Sea Link

**Volume 9: Examination Submissions**

**Document 9.4 Supplementary Environmental Information – Flood Risk Assessment**

**Planning Inspectorate Reference: EN020026**

## Plate 2.1 Extract from Thanet SFRA – River Stour FZ3b

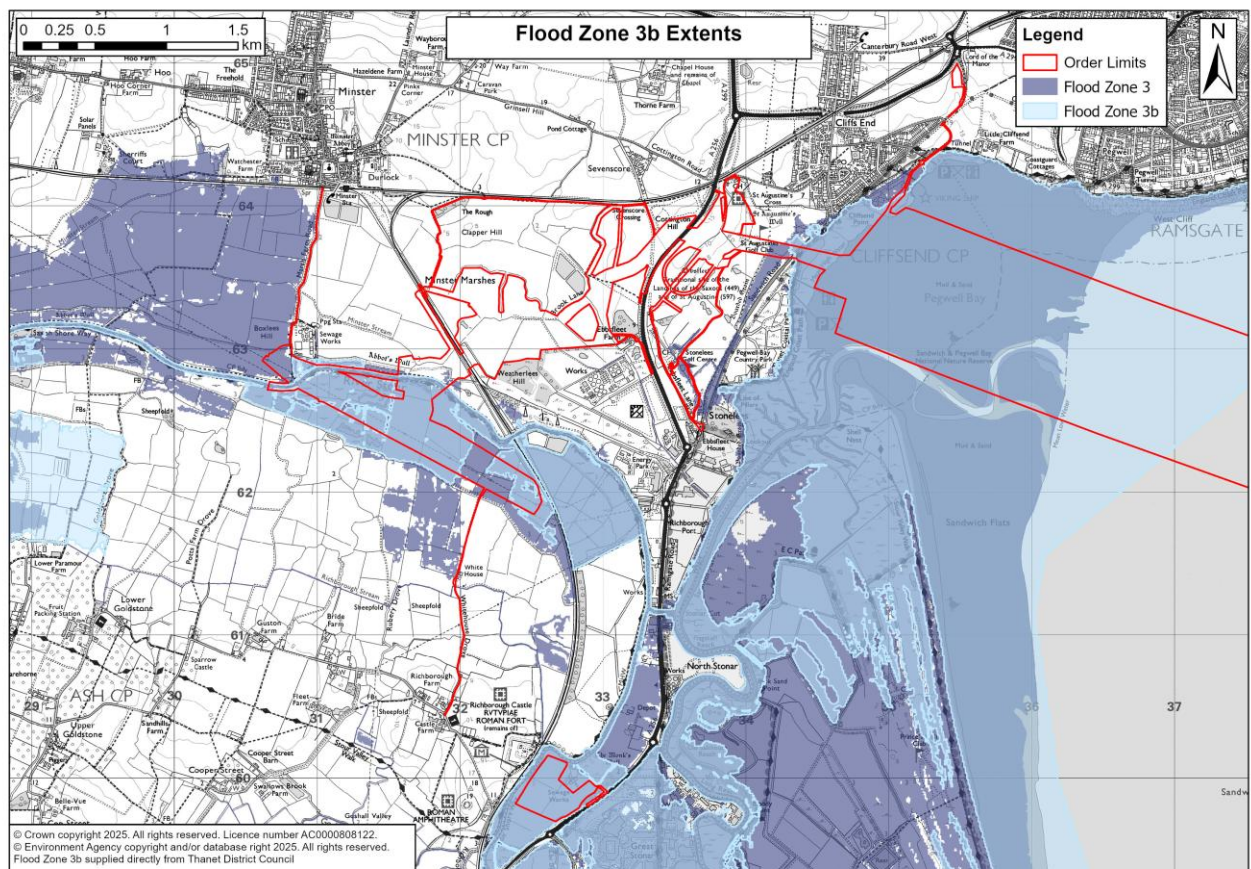
- “The FRA states that localised areas of the proposed development are in Flood Zone 3 (shown on Figure 1 of Appendix A). It does not distinguish between Flood Zones 3(a) and 3(b). The applicant is requested to provide plans showing Flood Zones 3a and 3b differentiated or explain why this information is not required in respect of the proposed development.”*

- 2.2.9 Flood Zone 3b for the River Stour is presented in the Thanet District Council Strategic Flood Risk Assessment (SFRA) (Thanet District Council, 2022) Appendix A.6. As illustrated in Figure 1 in Appendix A, it lies south of the River Stour and includes some land within the Order Limits.

- 2.2.10 In this area the Proposed Project activities primarily include works to existing overhead lines and pylons, as well as construction of new pylons. Pylon bases are not vulnerable to inundation and due to their open lattice designs would not impede flow within the functional floodplain. As the River Stour is tidally influenced at this location, it has also

been established, in agreement with the Environment Agency, that compensation for the very minor losses of floodplain storage associated with these works are not required.

- 2.2.11 The proposed temporary crossing of the River Stour via a single span bridge would be similarly resilient to flooding and its design will be such that impacts on flows of water within Flood Zone 3b would be very localised and minor.

- 3.1.6 Flood Zone 3b for the River Stour has been defined in the Thanet SFRA (see Figure 1 above). The Proposed Project would have no significant effects on the flow or storage of water within Flood Zone 3b in this location due to the nature of the proposed works, which do not have a large footprint and would not create barriers to the movement of flows within the functional floodplain of the river.
